**ADDENDUM NO. 2**

**City Facility Audiovisual System Upgrade Project  
CIP No. 337-37259**

SHEET NUMBER:  
**E101**

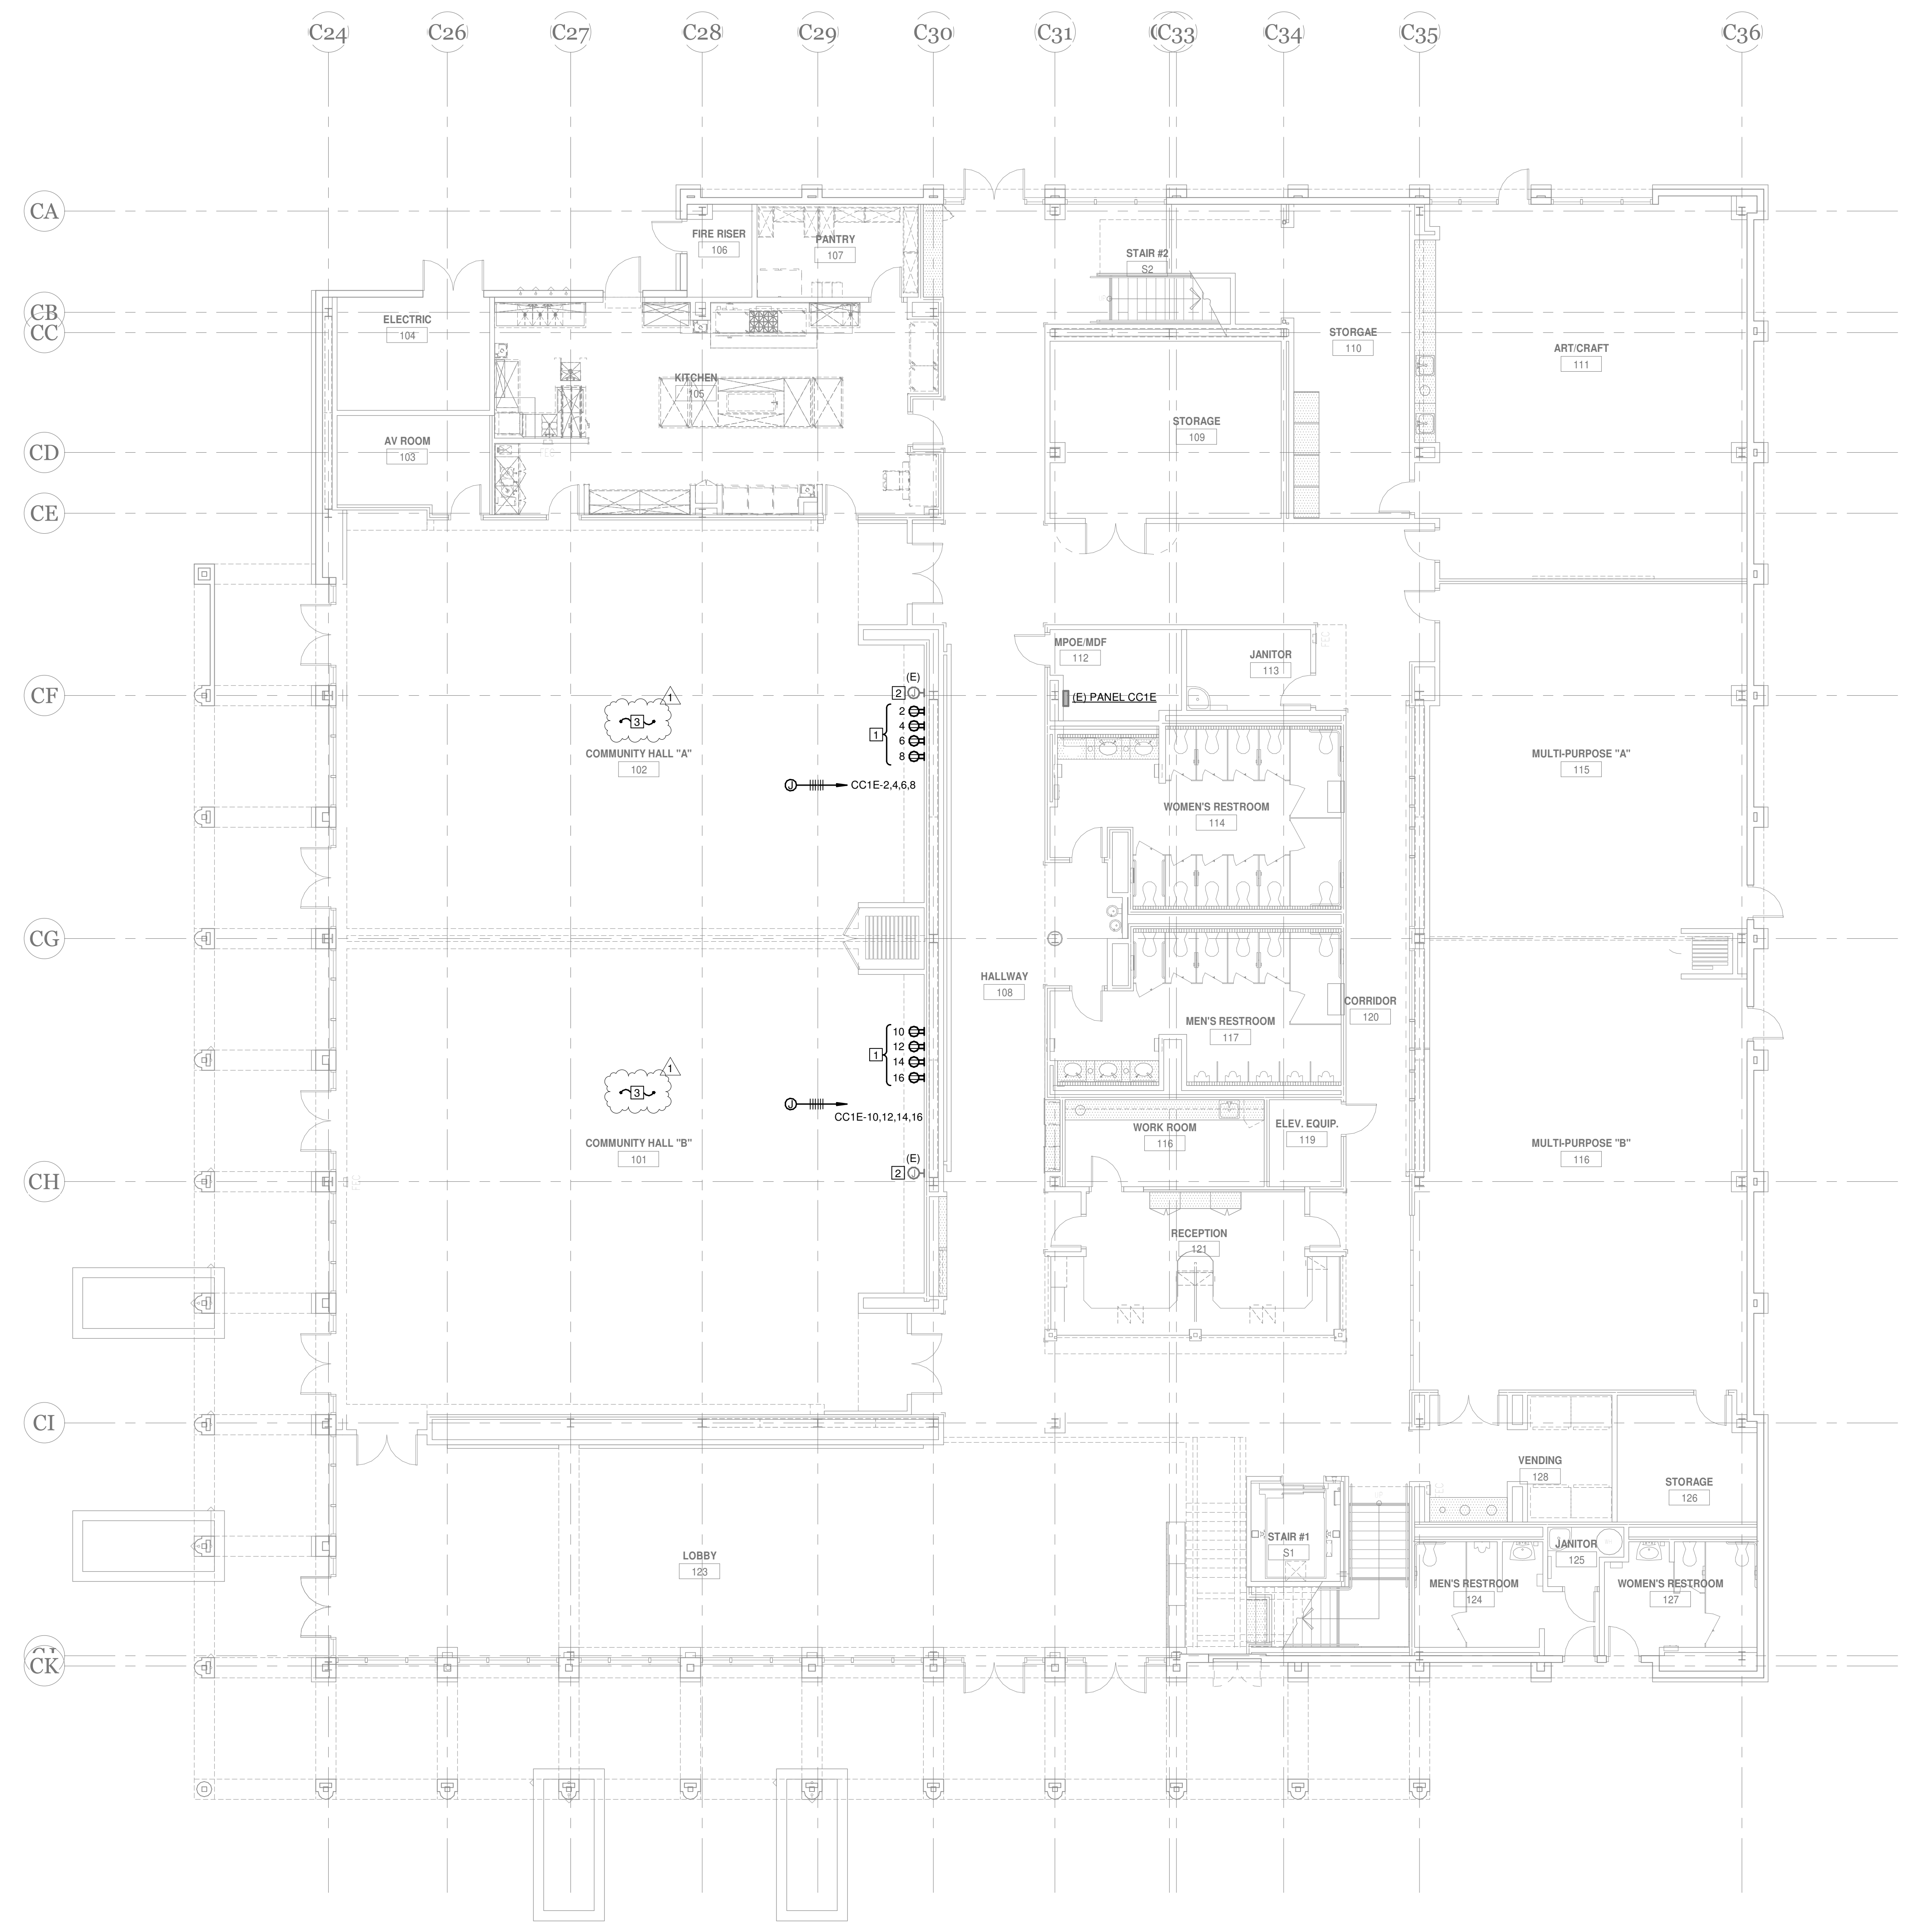
2. **Add** language related to reprogramming of existing Lutron lighting control panel (Appendix A – Plans Sheet E101)

- 3 THE CONTRACTOR SHALL INCLUDE IN THEIR BID REPROGRAMMING OF THE EXISTING LUTRON LIGHTING CONTROL SYSTEM IN THE MAIN SPACE OF THE CIVIC CENTER ('COMMUNITY HALL A' & 'COMMUNITY HALL B') BY A FACTORY CERTIFIED AUTHORIZED TECHNICIAN. SCHEDULE AN ON-SITE MEETING WITH THE OWNER'S REPRESENTATIVE TO DETERMINE THE OWNER'S REQUIREMENTS FOR LIGHTING CONTROL IN THE SPACE, INCLUDING BUT NOT LIMITED TO DEVELOPMENT OF SCENES, DIMMING REQUIREMENTS, TIME-BASED FUNCTION, SENSOR SETTINGS, AND INTERFACE WITH OTHER SYSTEMS. DEVELOP A SEQUENCE OF OPERATIONS FOR THE OWNER'S REVIEW AND APPROVAL, AND RE-PROGRAM THE SYSTEM. SCHEDULE A 4-HOUR REVIEW AND TRAINING SESSION UPON COMPLETION OF FACTORY START-UP SERVICES, AND INTEGRATE ANY FINAL PROGRAMMING REQUESTS.

**AV122**

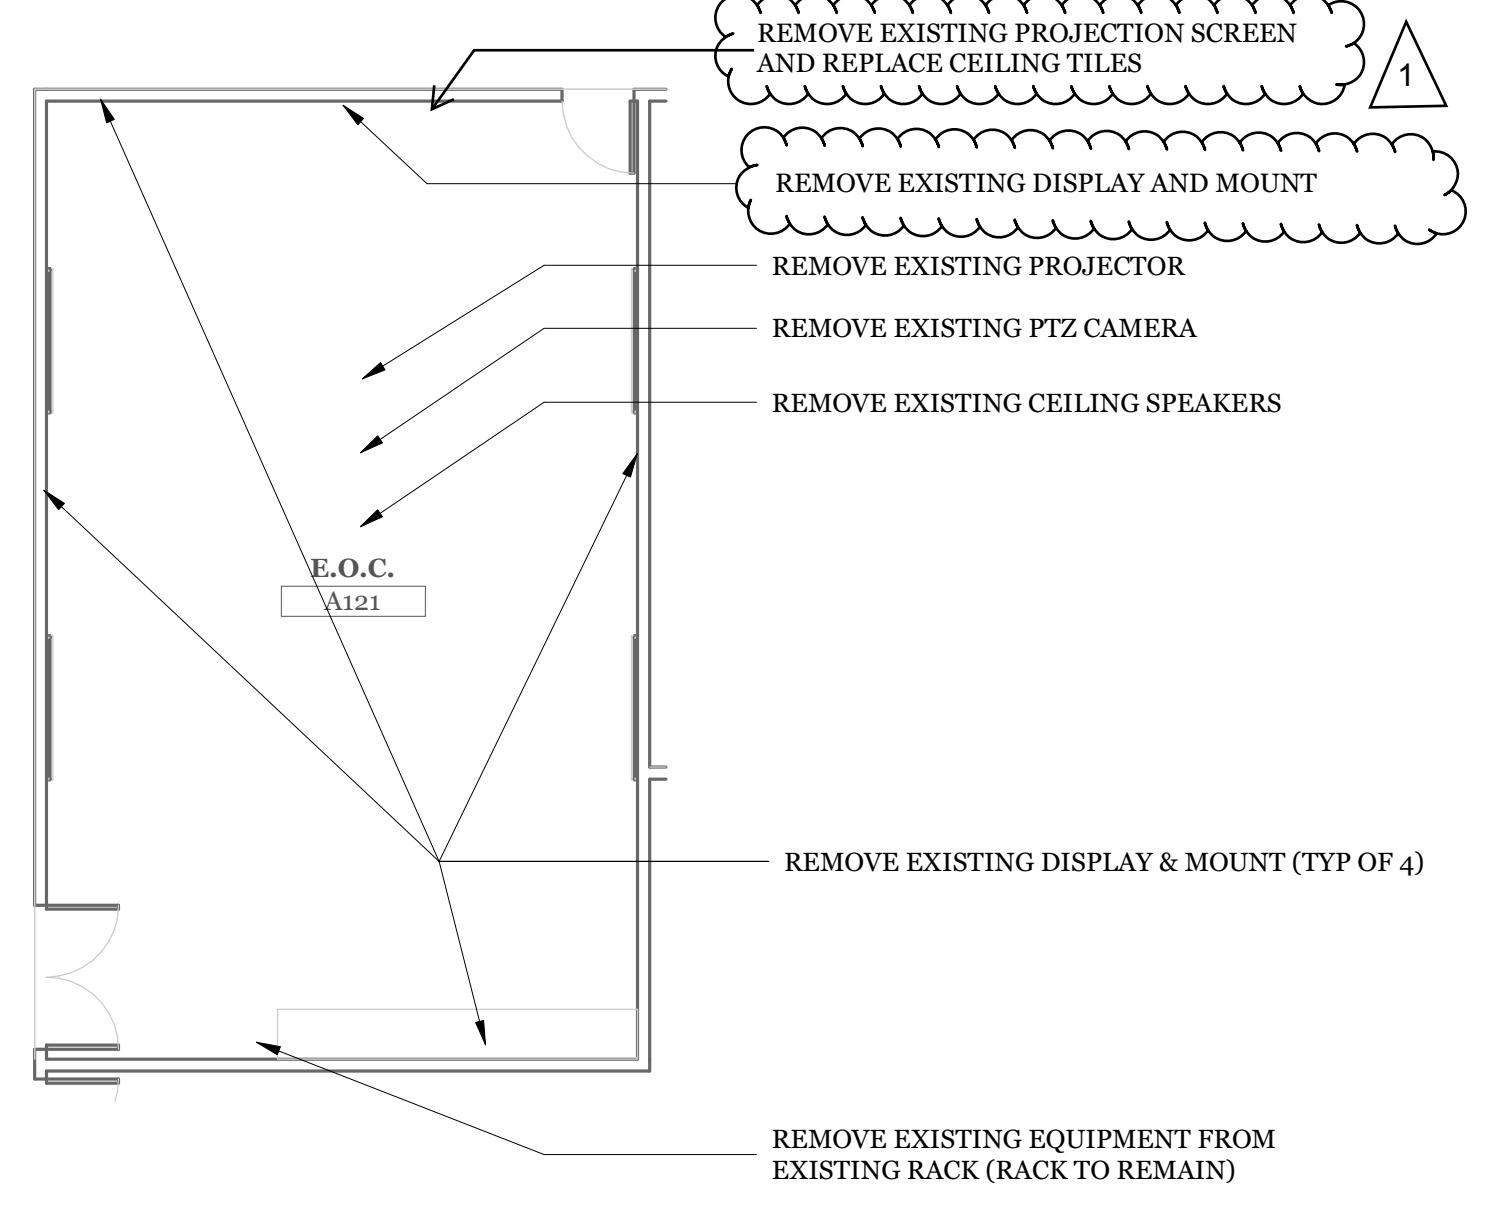
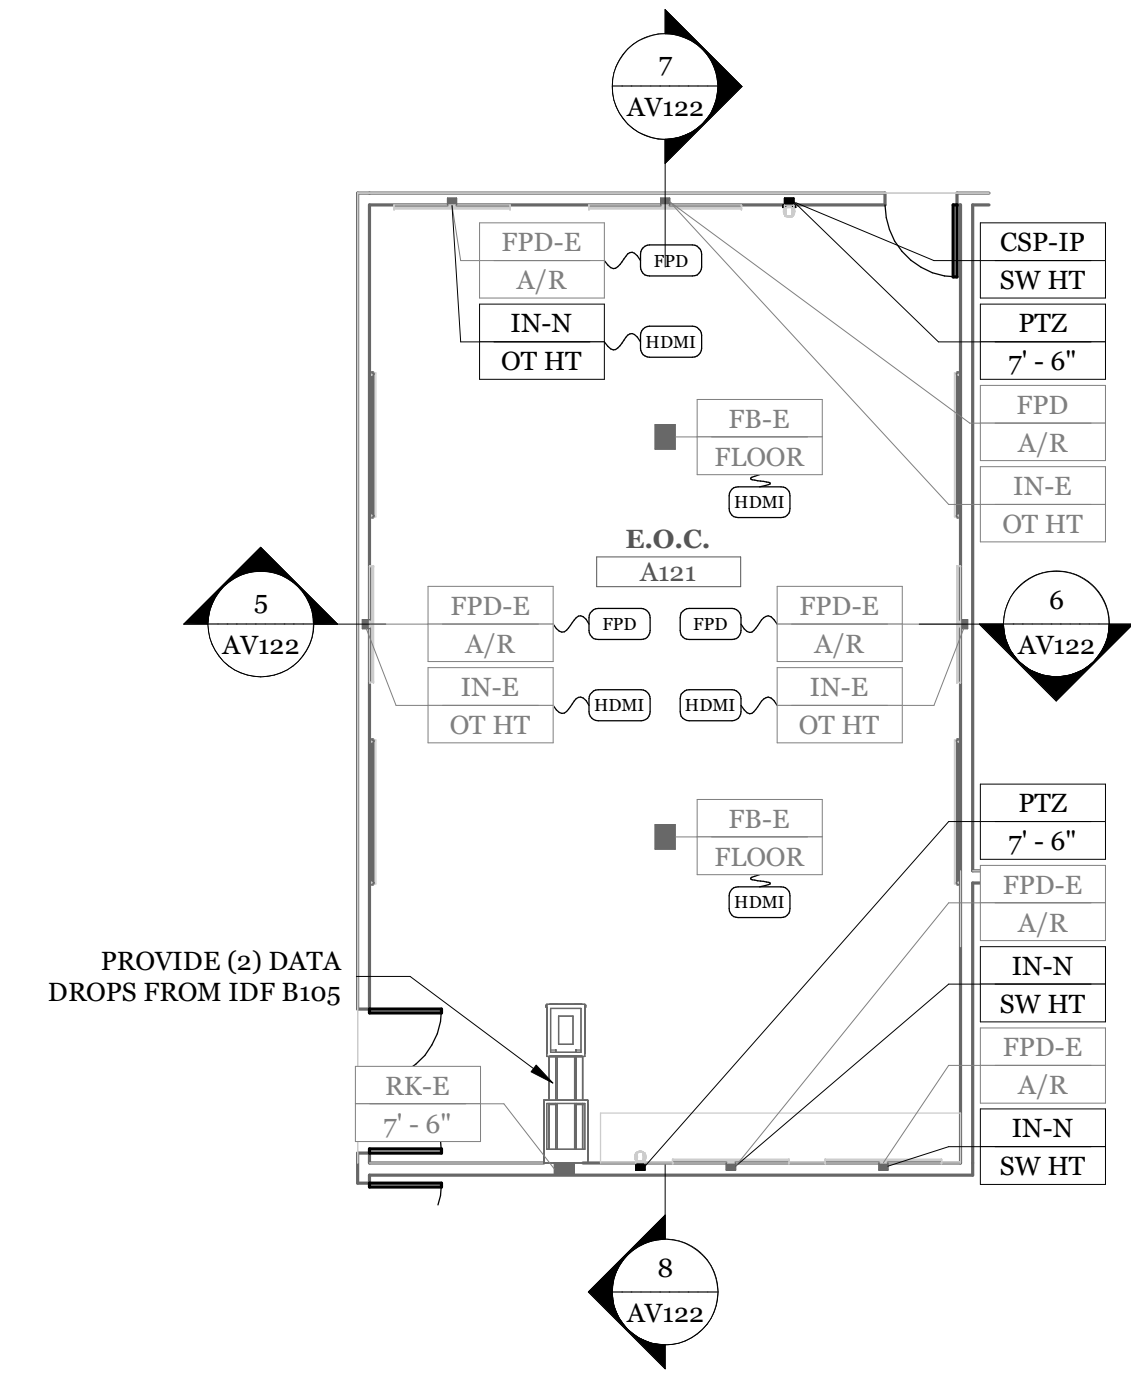
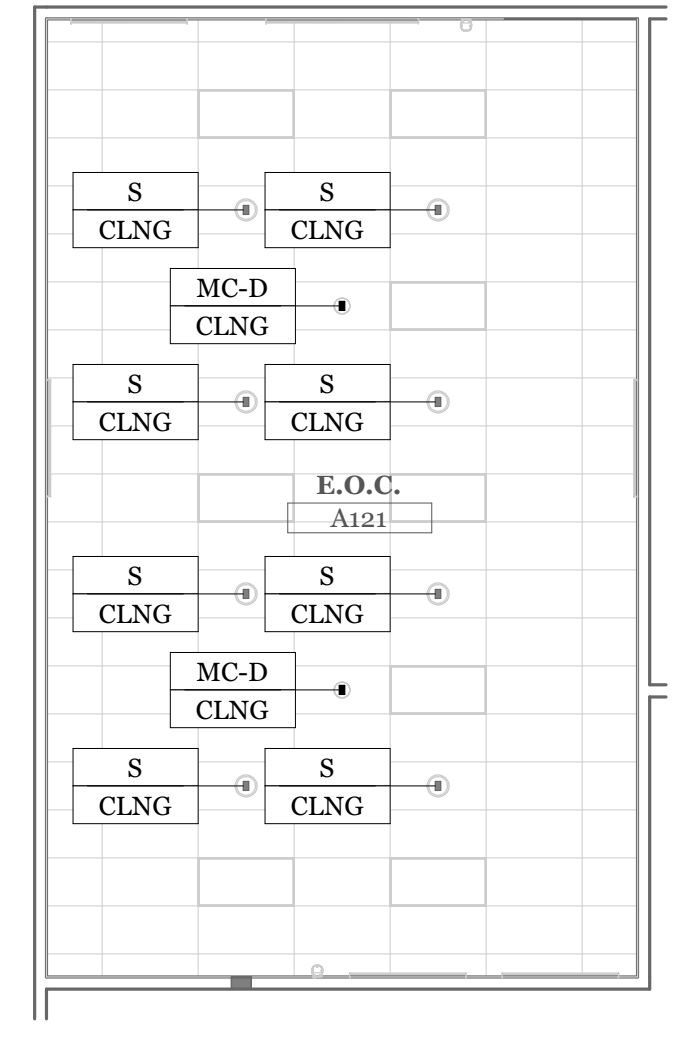
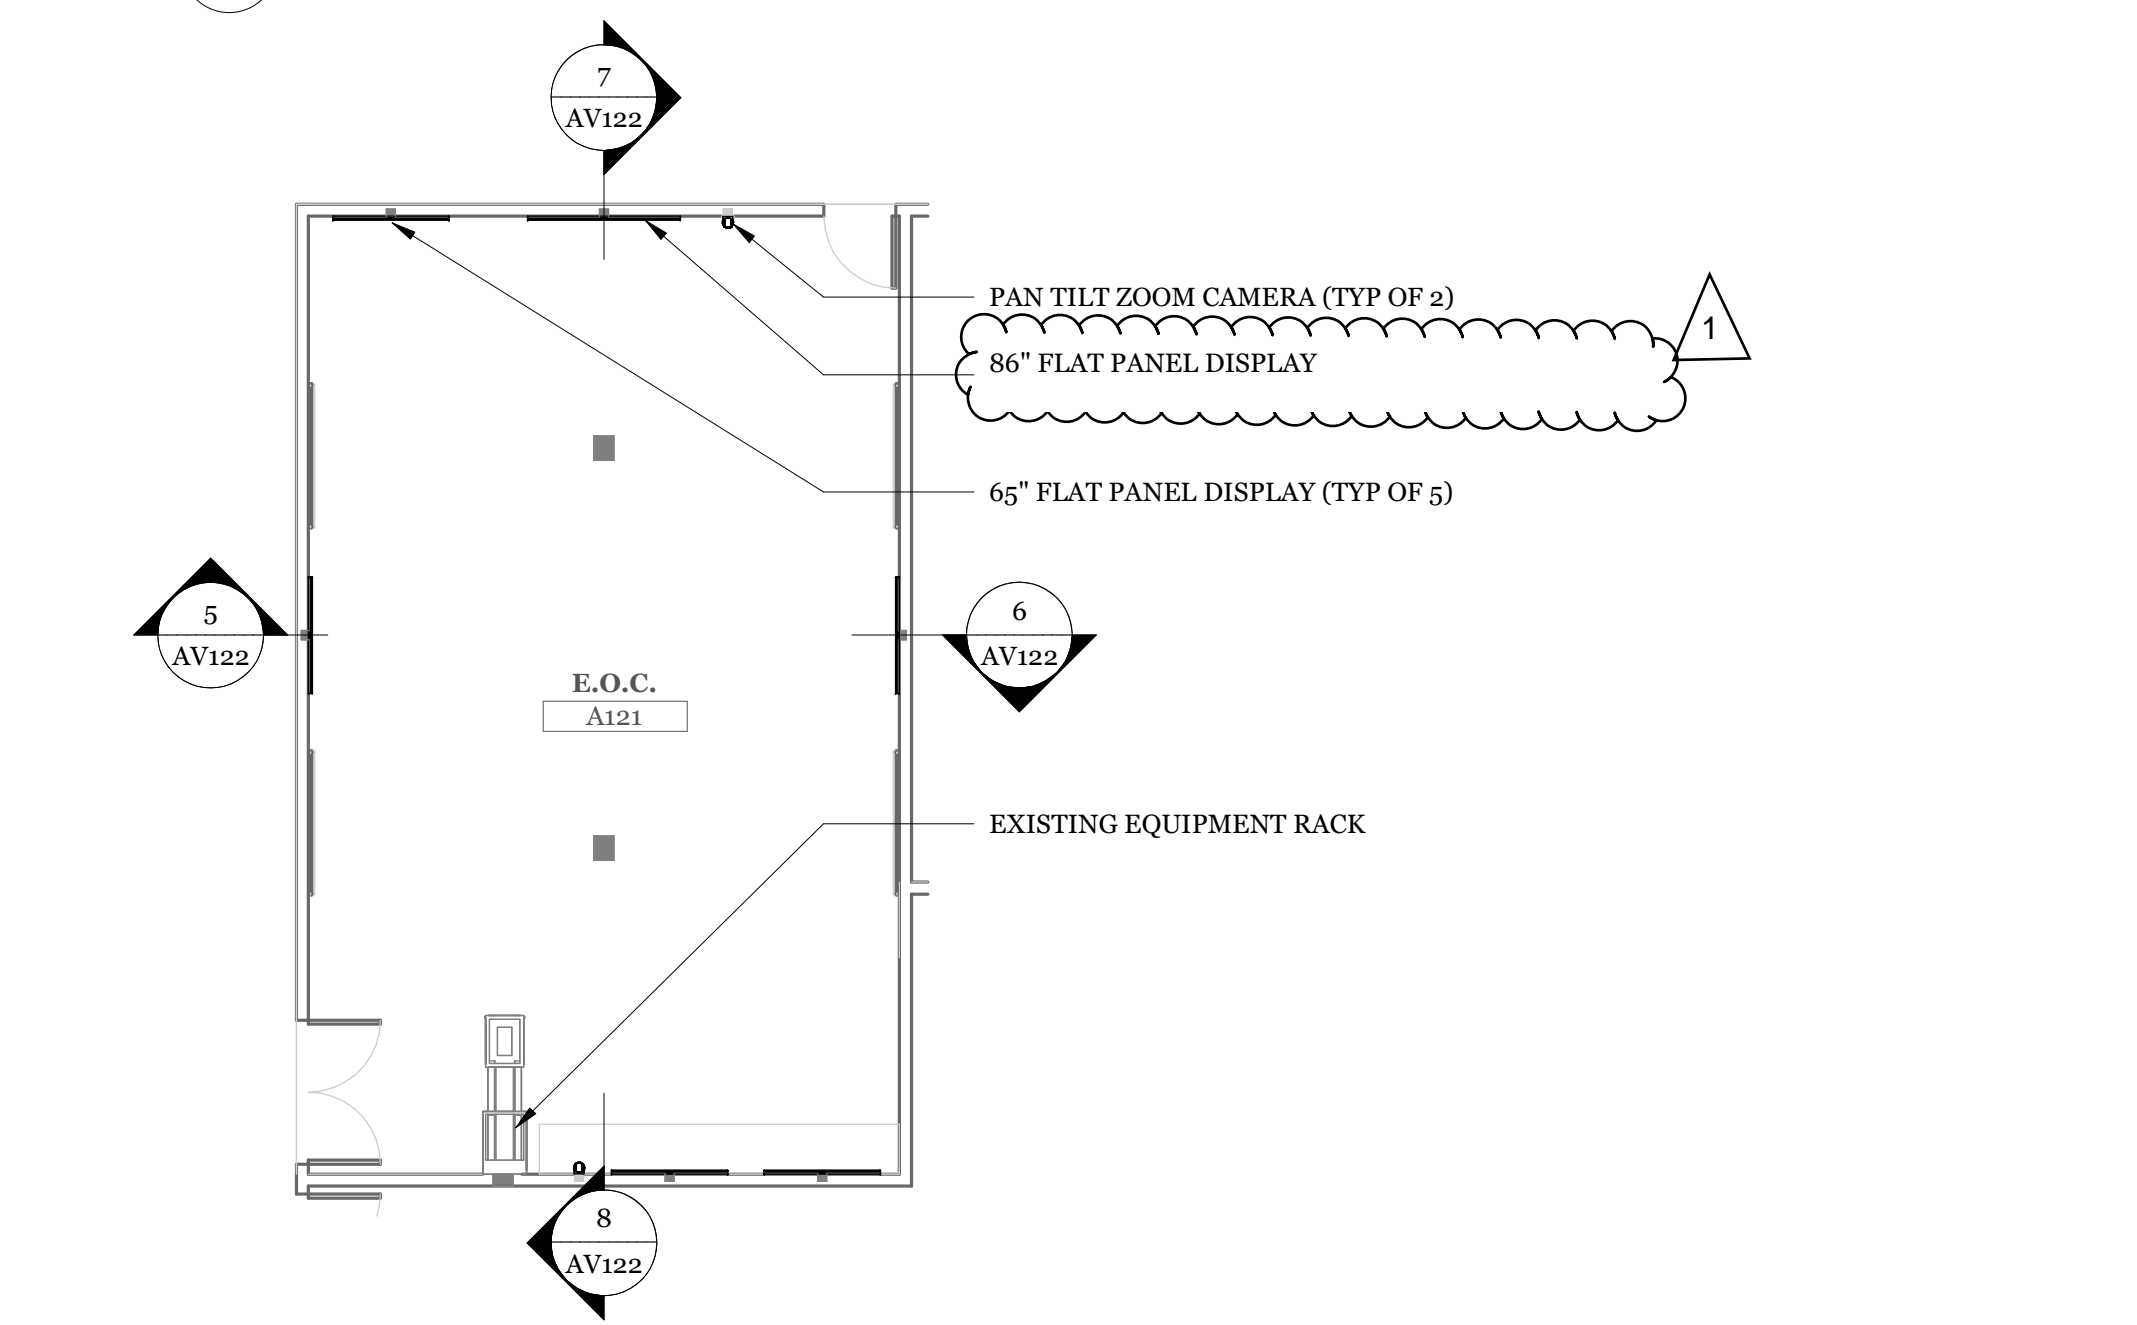
3. **Add** update to show removal of existing interactive flat panel and associated mount and removal of existing projection screen and replacement of ceiling tiles (Appendix A – Plans Sheet AV122)
4. **Modify** Police Dept./Video Systems – Bid Item #20 as follows (Equipment List – Spec 274116):
